RE: 2008 and 2009 Youth ATVs Lead Compliance Recall

Subject: **Youth ATV – Lead Compliance Recall**

No. **2009-6**

REVISION 1
March 20, 2009

Shock Protector Kit

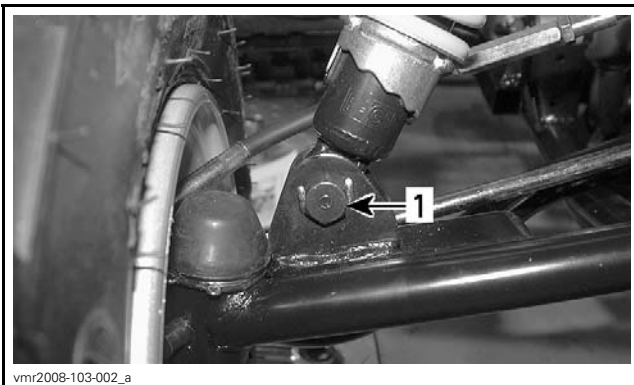
BRP will install suspension spring protectors to restrain the direct contact with the paint.

(P/N 706 201 147) SPRING COVER KIT ALL EXCEPT X MODELS			(P/N 706 201 148) SPRING COVER KIT X MODELS	
Item	Description	Qty	Description	Qty
P1	Front Suspension Springs Protector	2	Front Suspension Springs Protector	2
P2	Rear Suspension Spring Protector	1	Rear Suspension Spring Protector	1
P3	Locking Tie	6	Locking Tie	6

vbg2009-006-101

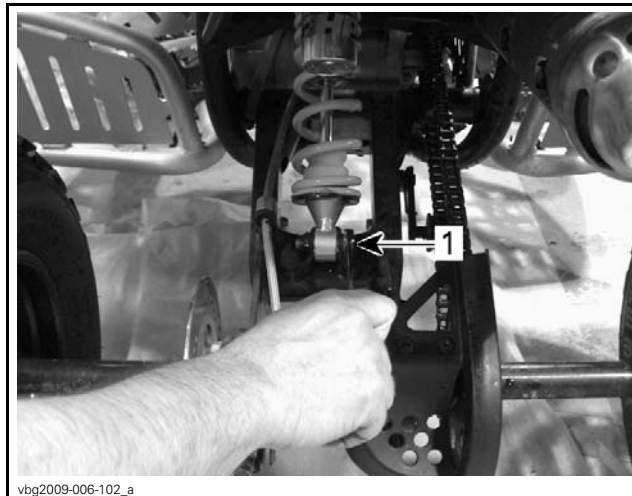
6. Install front suspension spring protector [P1] as per picture.

7. Secure front suspension spring protector [P1] with locking ties [P3].

10. Torque all bolts to 40 N•m (30 lbf•ft).

vbg2009-006-102_a

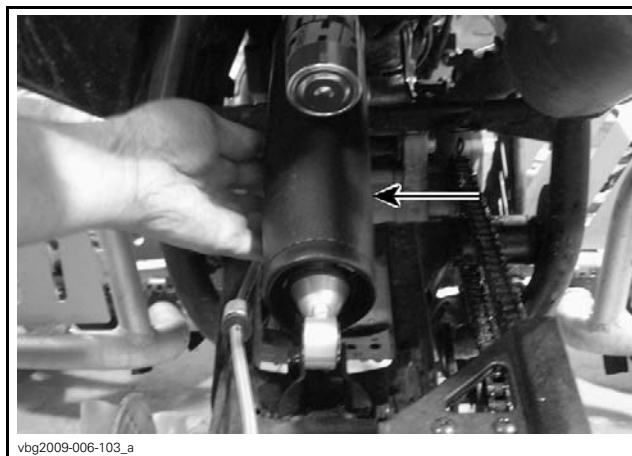
4. Install rear suspension spring protector [P2] as per picture.

5. Secure rear suspension spring protector [P2] with locking ties [P3].

8. Torque all bolts to 40 N•m (30 lbf•ft).
